# REPORT / RECOMMENDATION

**Subject:** Traffic Safety Committee Report of October 1, 2014

## Traffic Safety Report of October 2014

*Photo : Interlachen Blvd, east of Blake Rd, looking west*

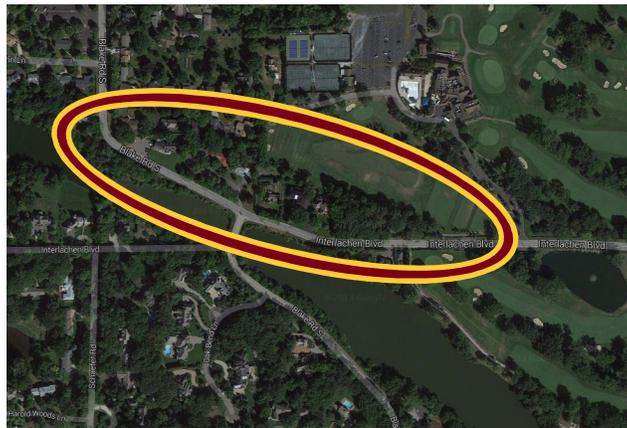
This request comes from a resident who feels that the bike lanes on Interlachen Blvd are dangerous as Interlachen approaches, and becomes Blake Rd, due to decreases in width and the state of repair of the road. Measurements of the lane widths were taken, and the lane for bicyclists reduces in width to 6 inches, while the state minimum for bicycle lanes is 4 feet, with at least 3 feet of width being free of obstacles and of consistent riding surface. Edge lines are warranted for use along grade separated roadways and on rural arterials which exceed 20 feet in width, and 3,000 in ADT, or elsewhere where an engineering study indicates a need for edge line markings. Interlachen has 9758 ADT and 85<sup>th</sup> percentile speeds of 35.6 mph (2013 MSA count), on the west end of this section and had 7846 ADT and an 85<sup>th</sup> percentile speed of 36.3 mph on the east side of this section (count done in 2005). No bicycle related accidents, and one rollover accident have been reported in the last five years. Further striping detail is in Appendix A, with visuals for possible alterations.

**After review, staff recommends restriping Interlachen and placing signs at this location as is shown in the visuals in the Appendix. This recommendation is based off the requirements for bike lanes, their current condition, and standards for vehicle lane widths.**

Map : 76<sup>th</sup> St and Metro Blvd

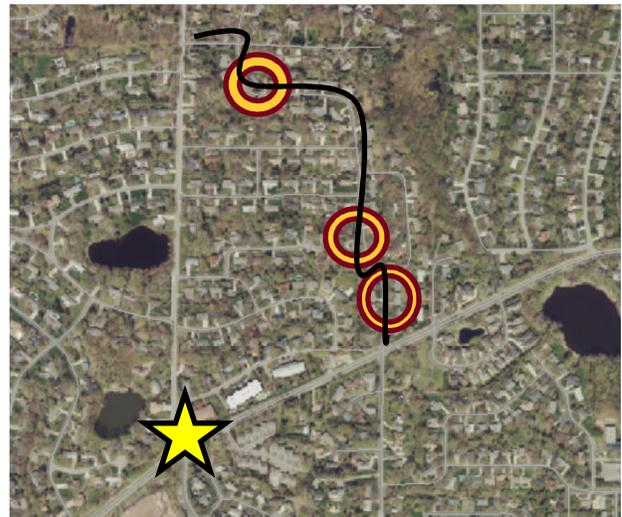
A request was made for a crosswalk across Metro Blvd. at 76<sup>th</sup> St. A pedestrian count was taken from 10:30 AM on August 18<sup>th</sup>, to 4:00 PM on August 19<sup>th</sup>. The maximum pedestrian count for pedestrians across Metro in a two hour period in this time was 18 crossings, with 61 crossings taking place during the study, 38 of which were on the south side of 76<sup>th</sup> St. This crossing does not meet the volume warrant for a crosswalk. Crosswalk warrants are attached in Appendix B.

After review, staff recommends denial of this request based on not meeting volume warrants for a marked crosswalk.

Appendix A: Interlochen Boulevard Striping

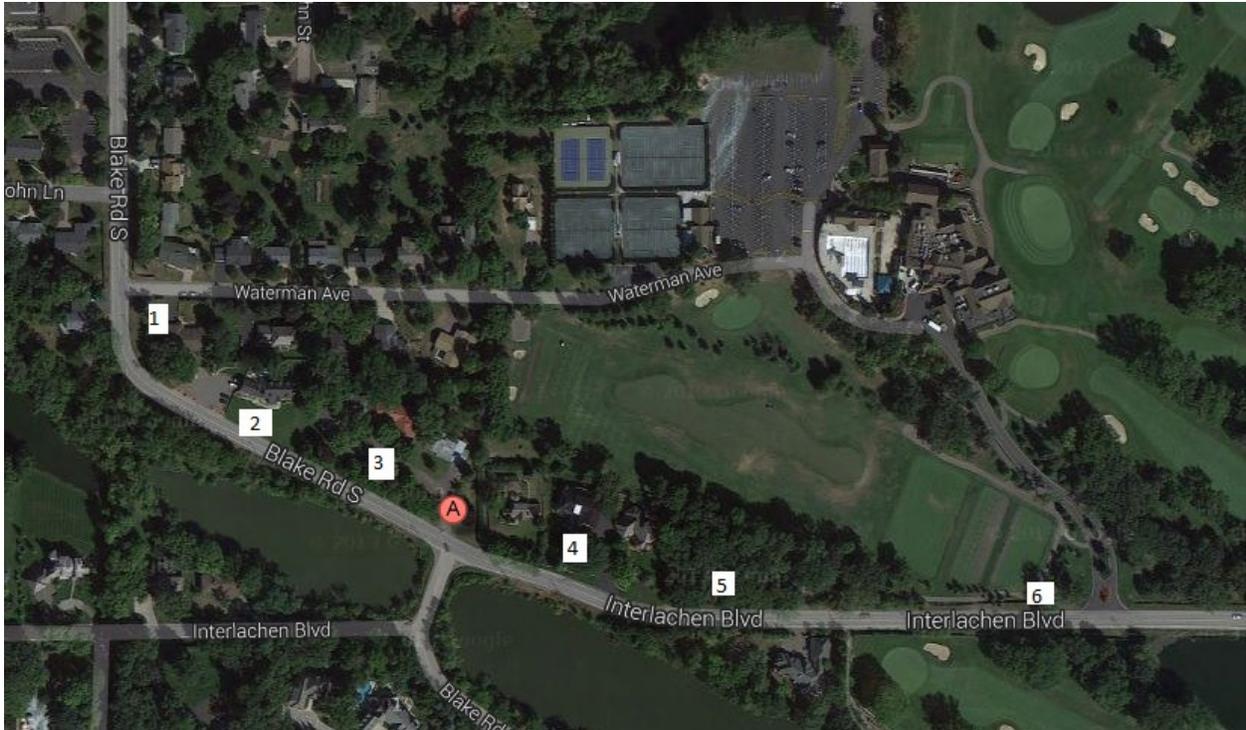
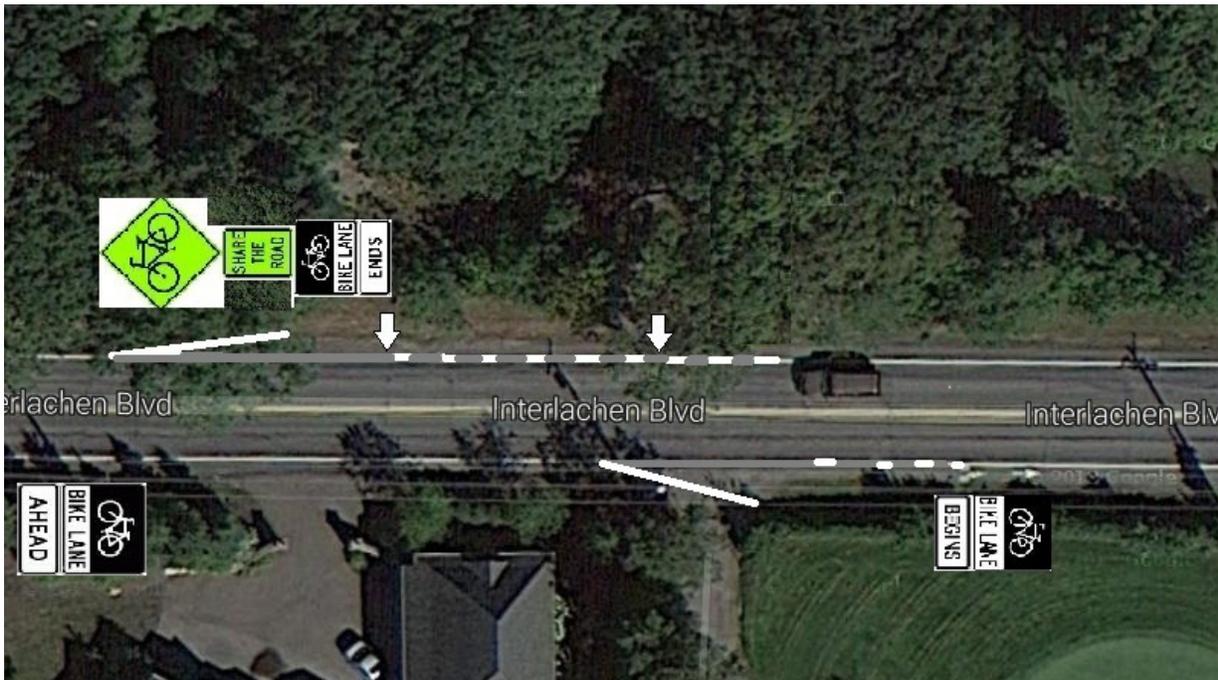
Possible signage and striping, at points 1 and 5 (approximately), based off MNMUTCD designs for a through, motor-vehicle lane drop.
